AS-BUILT DRAWINGS

MILK CREEK IN-STREAM AND RIPARIAN ENHANCEMENT

UNITED STATES DEPARTMENT OF AGRICULTURE
NATURAL RESOURCES CONSERVATION SERVICE

COVER SHEET - AS-BUILTS

PLAN VIEW

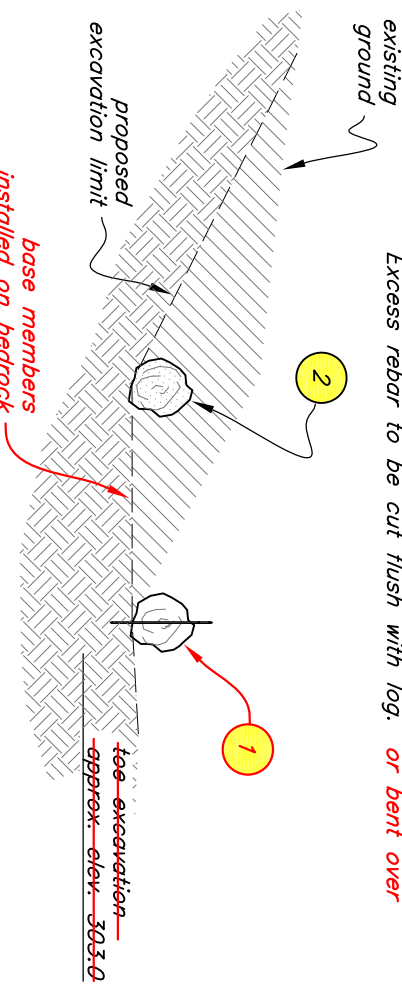
changed base members to 24" dbh logs with no rootwads

LOG MATRIX TIER 2

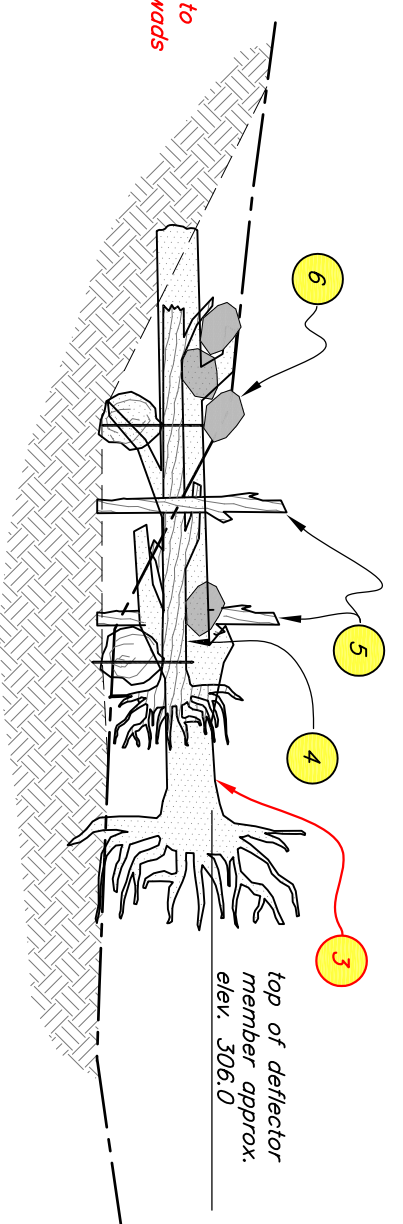
bedrock prevented embedment

LOG MATRIX TIER 4

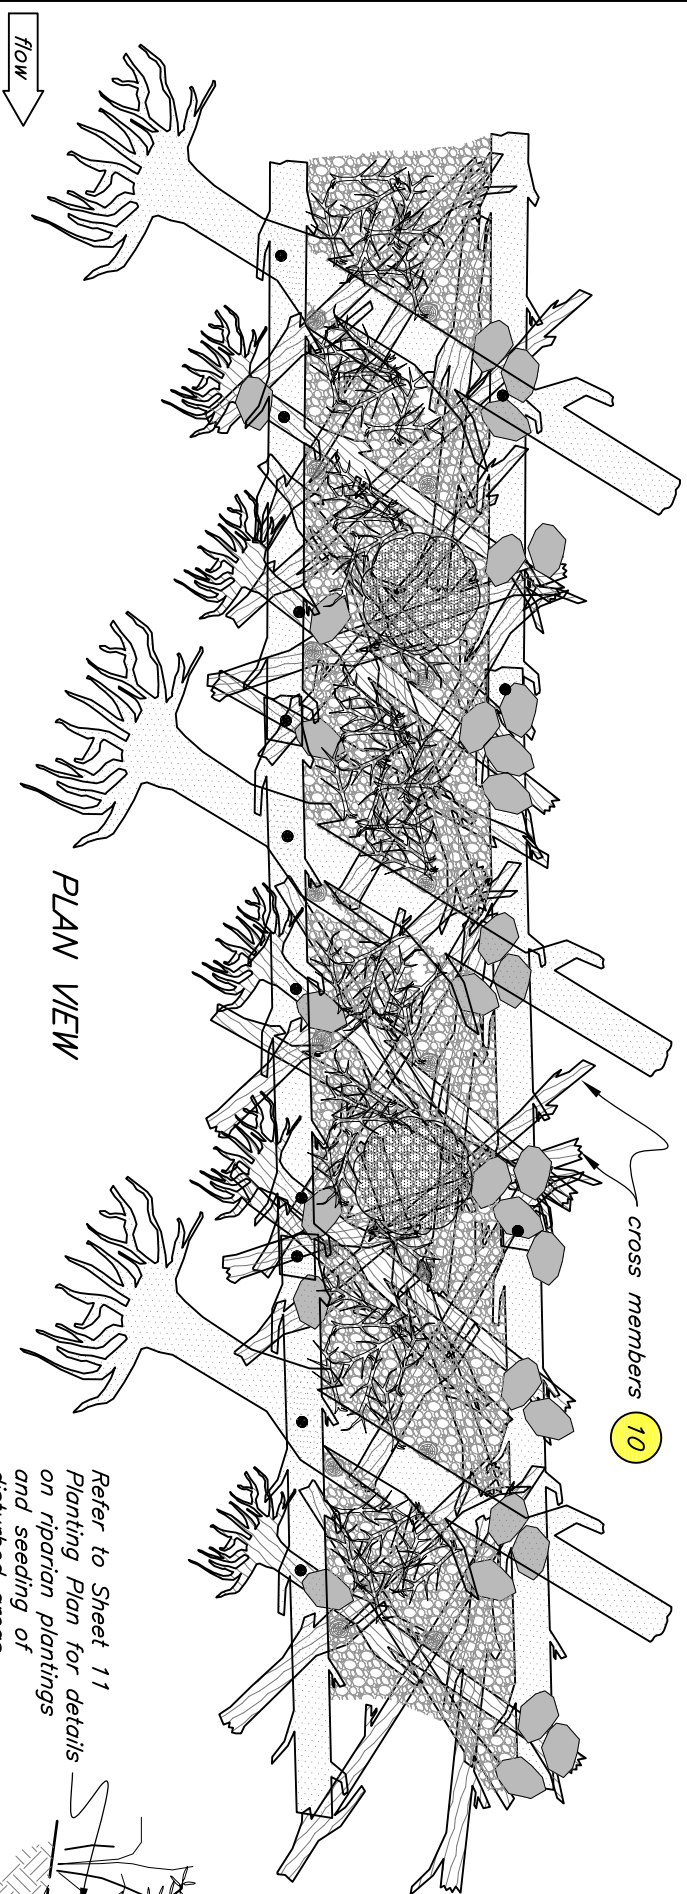
6" minus angular rock imported as additional backfill

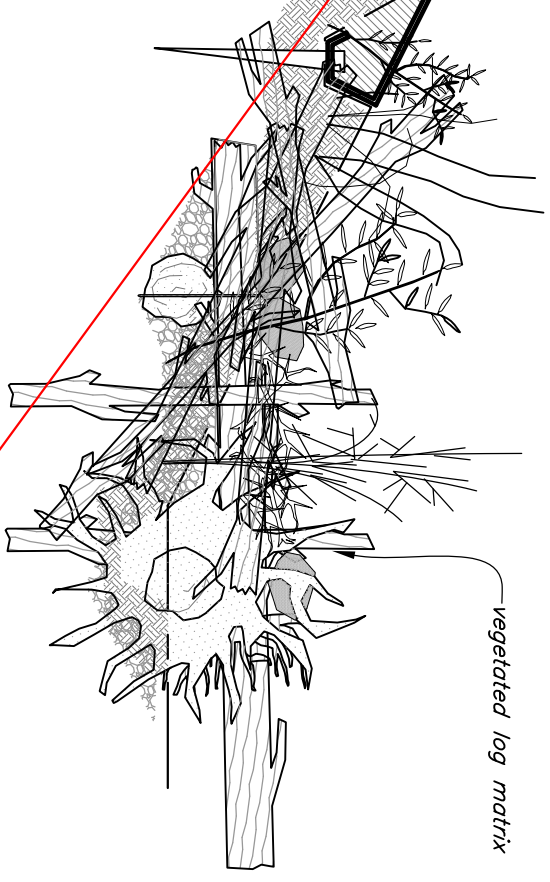
Bank shaping and erosion control fabric not needed.
